Draft Sydenham Park Master Plan Addendum Update Report 2021

Prepared by Pollen Studio for Brimbank City Council
OCTOBER 2021

1.2 Sydenham Park Master Plan 2020 - Proposed Addendum Updates

Figure 1. Draft Sydenham Park Master Plan Addendum Update 2021.
1:10000 @A3

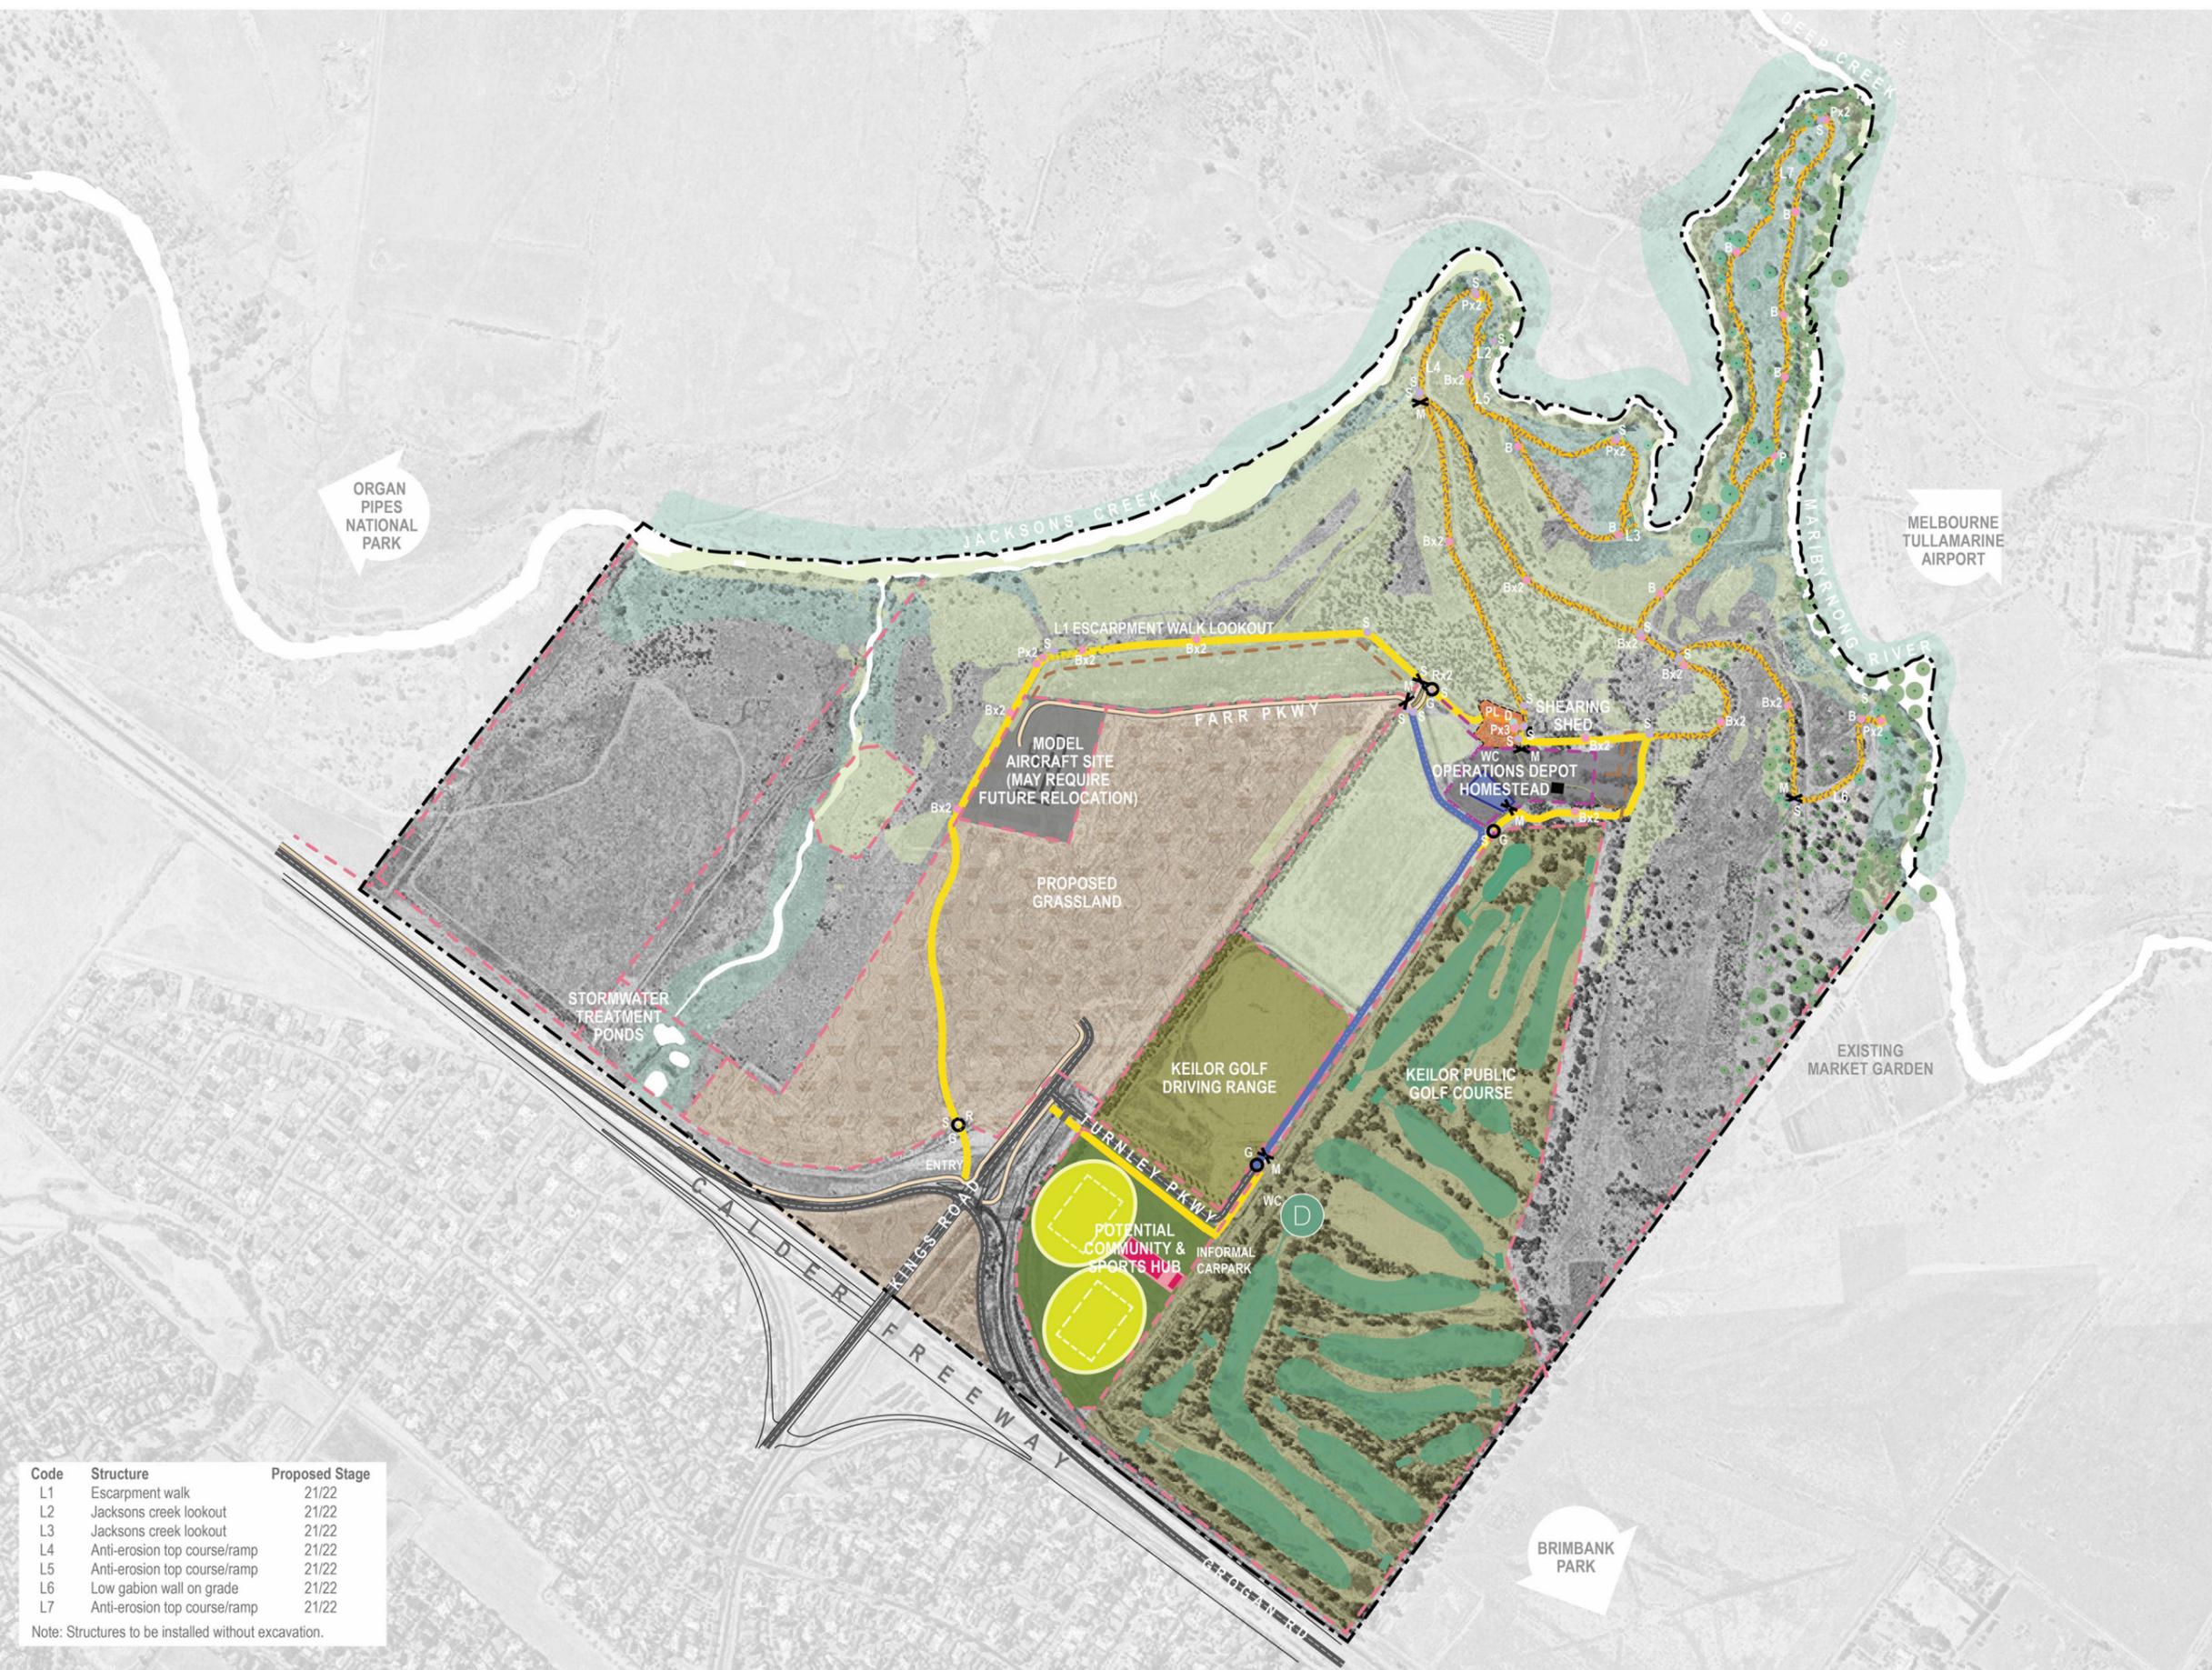
- Final layout of walking trails that includes a new Shared User Path (shown in red) that creates a circuit from Kings Road Interchange in to Sydenham Park that includes a loop around Robertson’s Homestead and back to Kings Road via the existing road alignment.

- Upgraded existing paths (shown in blue) to enable walking in to the river valley including the confluence of the Maribyrnong River. Includes a new loop at the confluence of the Maribyrnong River

- Proposed locations for new lookout, seating, signs, gates, fencing, bins and drinking fountain.
- ‘Potential Future Sports Field Expansion’ component within the existing Golf Course to be removed as no longer required given Council was not successful in its Expression of Interest for the Home of Football (Matildas) Bid and the area proposed for the replacement golf holes would not be suitable given the high level of artefacts and biodiversity.

- ‘Possible Future Sports Field Expansion’ component proposed to the west of Kings Road to be removed due to (1) the alignment of the Shared User Path through this area, which was chosen to limit its environmental impact while providing the best connection to the Kings Road Shared User Path, and (2) the majority of this area is affected by the Melbourne Airport contours in relation to Lighting Distractions which may impact on lighting provision for future sports facilities, and (3) this area is considered more appropriate as a potential revegetation zone for grassland species. This revegetation is seen as a crucial component of improving biodiversity in Sydenham Park in the long term by creating a new seed source. The seeds produced will be used for propagation of new grassland species for use in revegetation works across Sydenham Park. Extent and timeframes of grassland restoration will be considered by Council as part of future Annual Budget processes.

- ‘Potential Commercial Opportunity’ component also proposed to the west of Kings Road to be removed, as this area is considered more appropriate as a potential revegetation zone for grassland species, as per the above dot point.
